③ EXPLANATION  
OF CHANGES  
PROPOSED

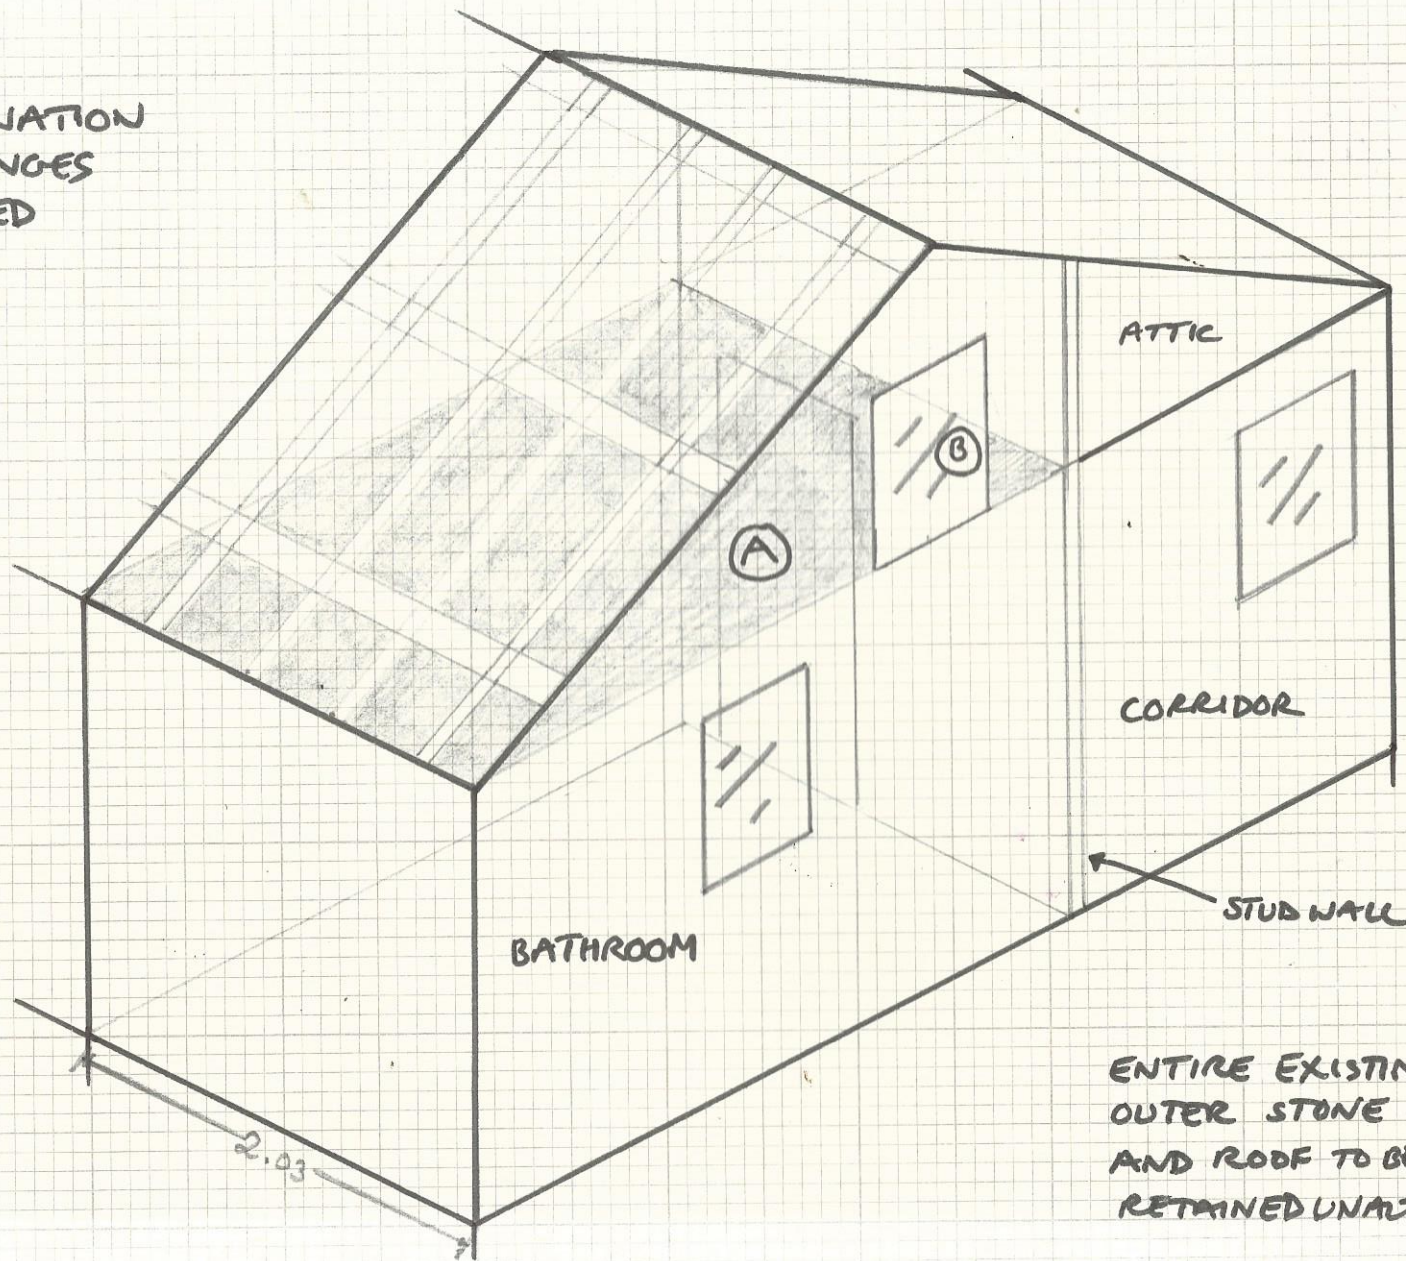
ENTIRE EXISTING  
OUTER STONE WALL  
AND ROOF TO BE  
RETAINED UNALTERED.

Ⓐ PLASTERBOARD CEILING REMOVED (SHADED AREA)

Ⓑ DOUBLE GLAZED WINDOW TO REPLACE  
BRICKED UP ORIGINAL WINDOW.  
EXISTING SILL & LINTEL (STONE)  
TO BE RETAINED.
